JSP25-07 Cadillac of Novi

PLAN REVIEW CENTER REPORT

Revised Preliminary Site Plan / Special Development Option Amended Concept Plan

Review Date: July 16, 2025
Review Type: Preliminary Site Plan
Project Name: JSP25-07 Cadillac of Novi
Plan Date: June 23, 2025
Prepared by: Dan Commer, Planner
Contact: E-mail: dcommer@cityofnovi.org Phone: 248.735.5607

BICYCLE PARKING DIMENSION PLAN
SCALE: 1" = 60'

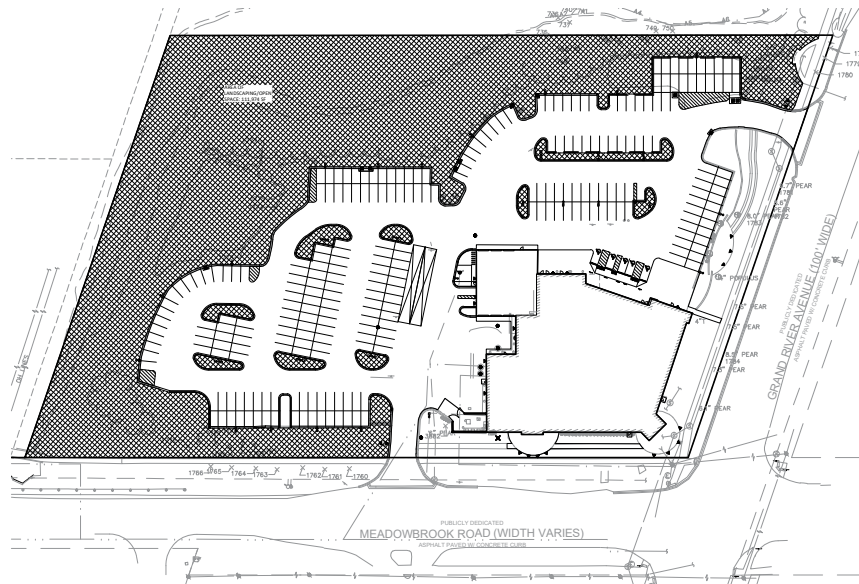
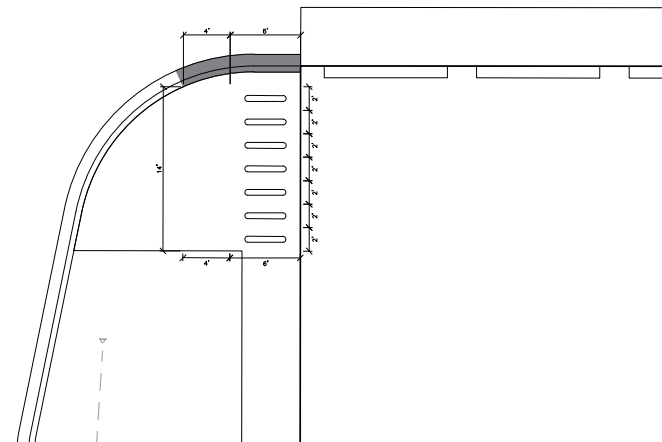
9. Bicycle Parking General Requirements (Sec. 5.6): The Preliminary Site Plan showed that all 7 bicycle parking spaces were provided in one location and the layout was not dimensioned. *A dimensioned bicycle parking layout has been provided on sheet C10 as requested with the revised submittal; however the dimensions are still citing the old standards, and all spaces are still proposed in one*

location. Please refer to Planning Review Chart for additional information, and see [Text Amendment 18.301](#) update to bicycle parking layout standards before Final Site Plan consideration.

Attachment A
Site Photographs

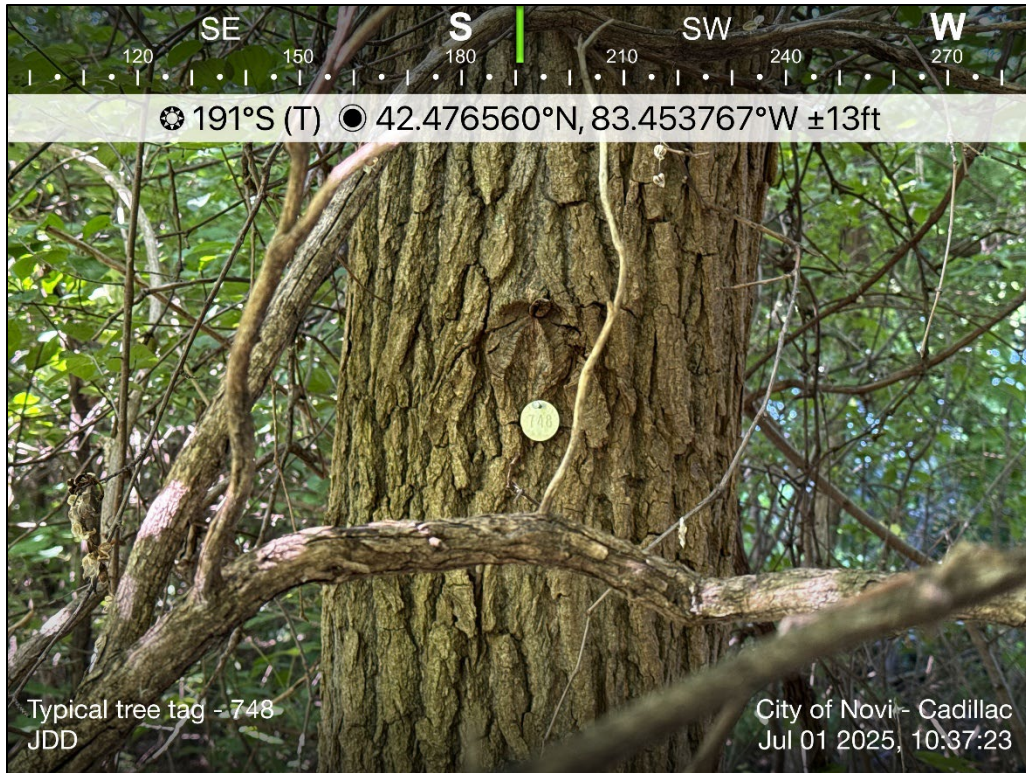
-
2. Note that both the woodlands and property limits depicted on the City map are considered approximations (**Figure 1**). Merjent conducted a site visit on April 29, 2025 and an additional site visit on July 1, 2025 to verify conditions on the updated site plan. Select photos from the site visits are included in **Attachment A**.
